FINAL ENVIRONMENTAL IMPACT STATEMENT

VOLUME III: RESPONSE TO COMMENTS

DEPARTMENT OF ENERGY
LOAN GUARANTEE TO ROYAL BANK OF SCOTLAND FOR
CONSTRUCTION AND STARTUP OF THE TOPAZ SOLAR FARM
SAN LUIS OBISPO COUNTY, CALIFORNIA

August 2011

TOPAZ SOLAR FARM: PROJECT LAYOUT 3B.1

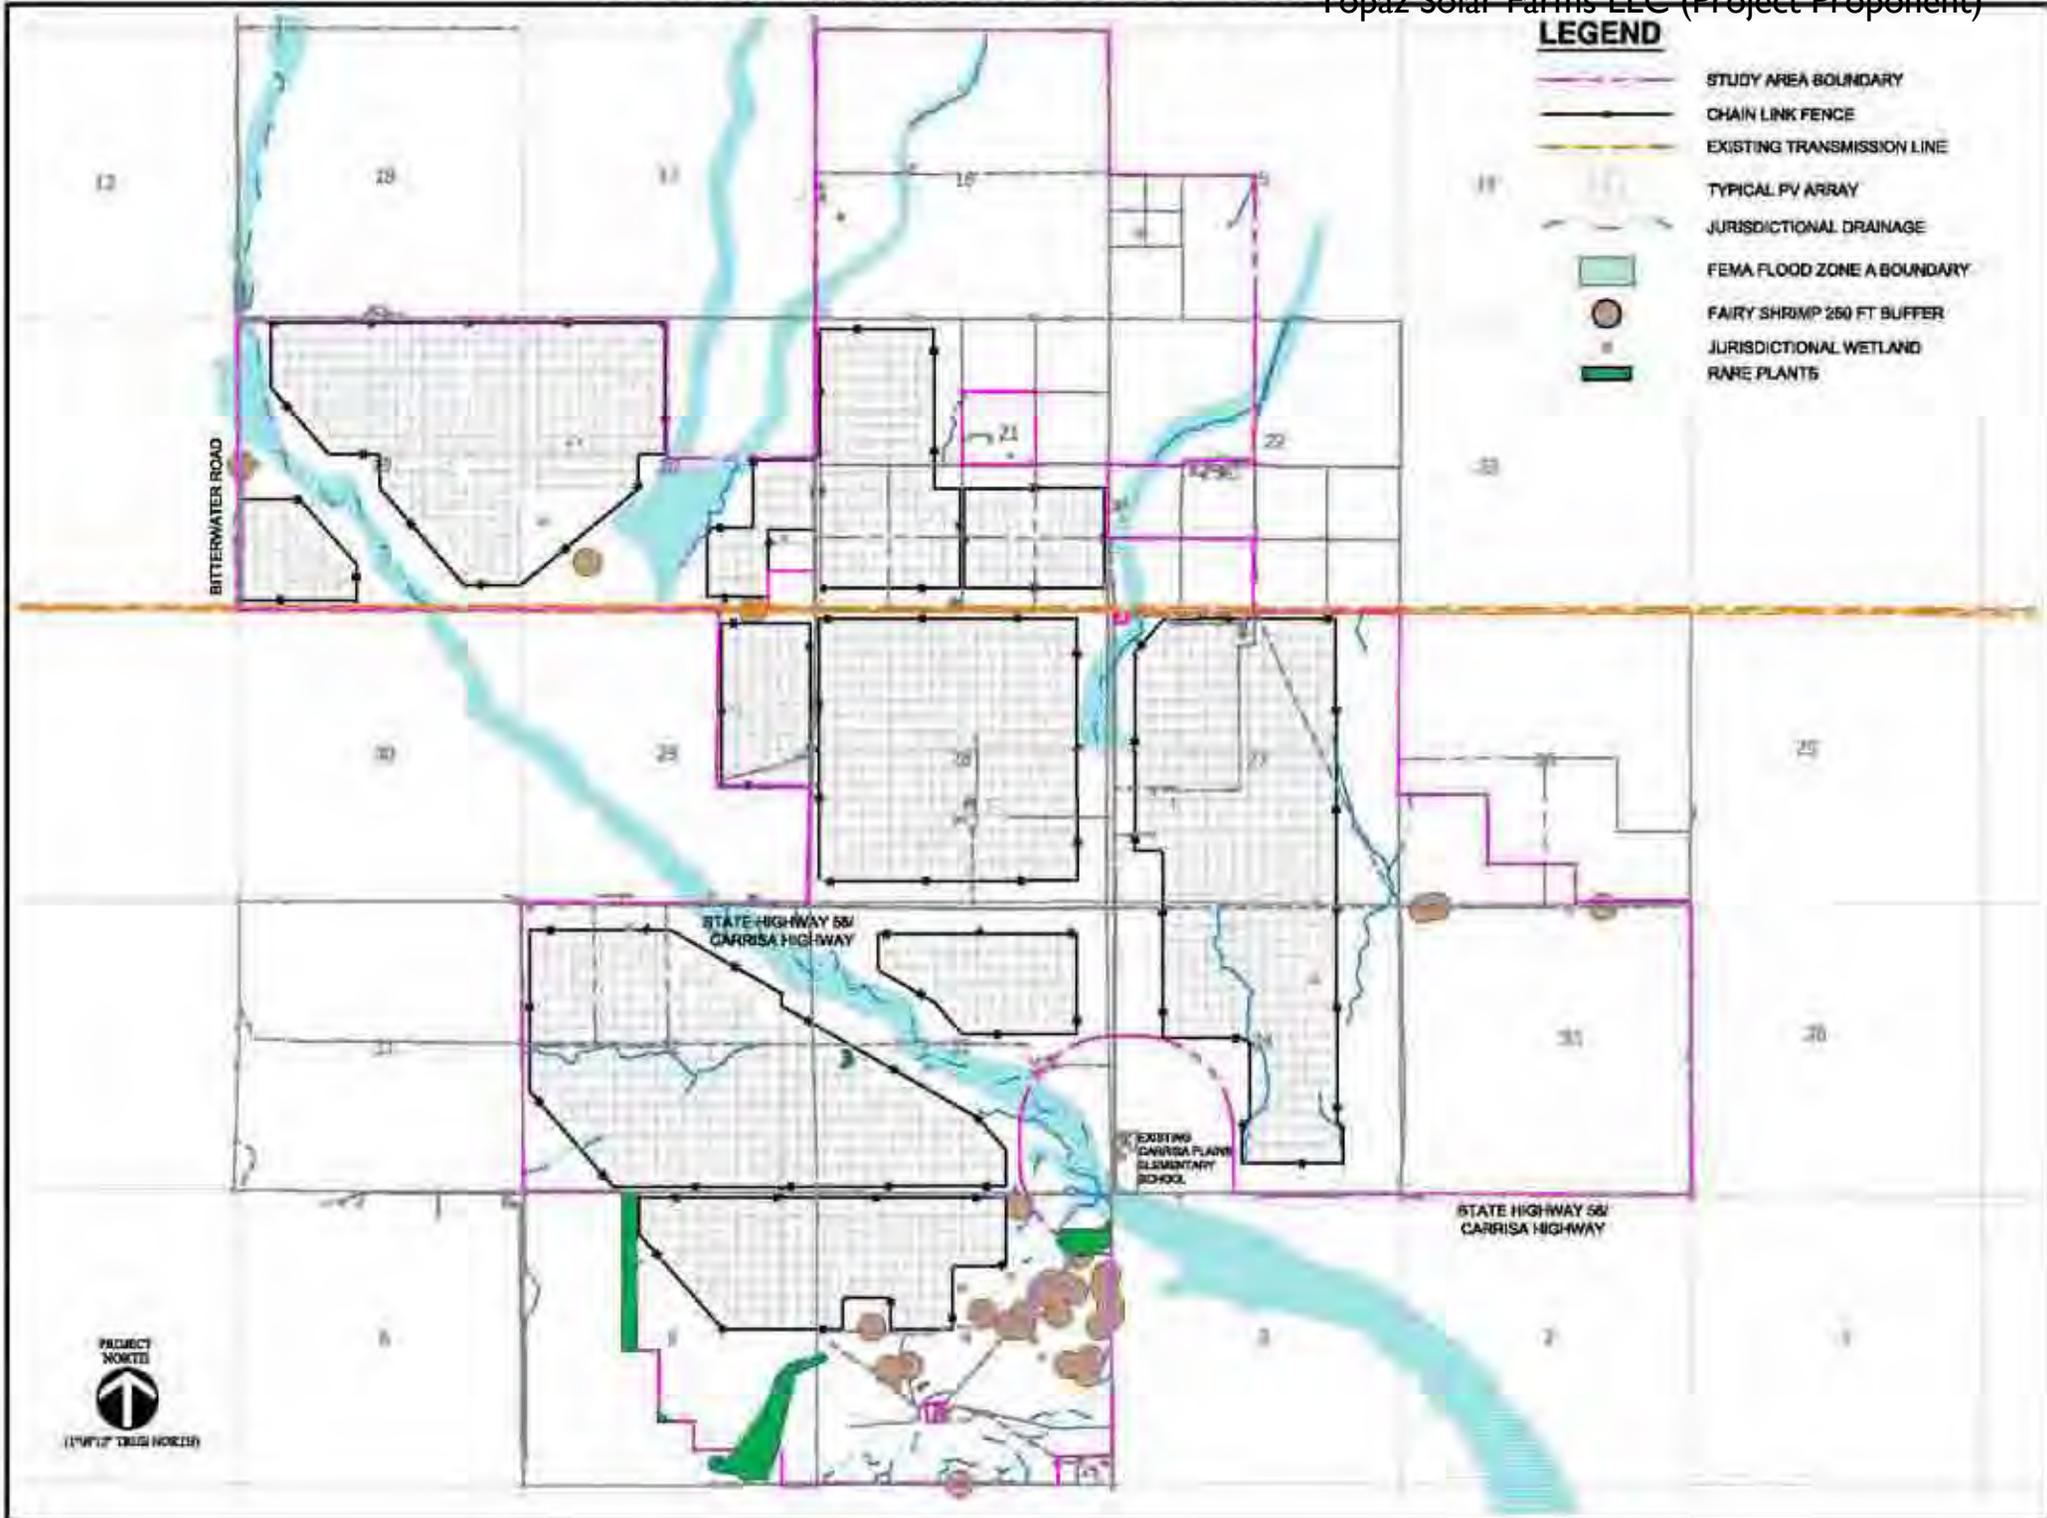
Comment PP-19: Please incorporate the attached map of Project Layout 3B.1 (Section 2.3.2, page 2-20, Solar Generating Equipment) into Figure 2-7 to update the “Reduced Acreage PV Array Layout.”

Please incorporate the attached map of Project Layout 3B.1 into Figure 2-7 to update the “Reduced Acreage PV Array Layout.”

Response to PP-19: The County-approved project layout has been incorporated into Figure 2-7 as requested.
